**Memo To:** Kaitlyn Graham, Project Manager  
**Memo From:** Michelle Wong, Senior Urban Designer

**Subject:** Official Plan Amendment/ Zoning By-Law Amendment  
**Applicant Name:** Weston Consulting  
**Municipal Address:** 47 and 59 Brookside Road  
**City File No.:** OPA-24-0007, ZBLA-24-0013  
**Related City File No.:** D06-20023

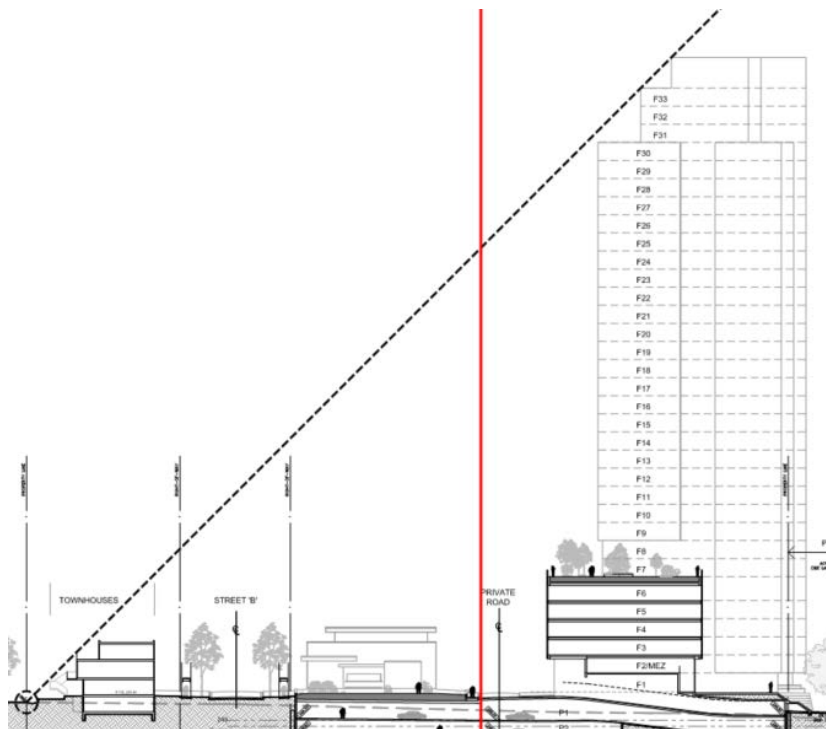
<p>6. <b>Angular Plane for Phase 3</b></p>	<p>In conjunction with the previous comment, please note that the angular plane shown for Phase 3 in the Section A-A and B-B drawings shall be measured from the nearest existing Neighbourhood designation line, in accordance with the Secondary Plan and By-law 111-17. To that effect, the angular plane must be drawn from the closest Neighbourhood designation line, as indicated in red below.</p>	<p>OP 3.4.1.5</p>
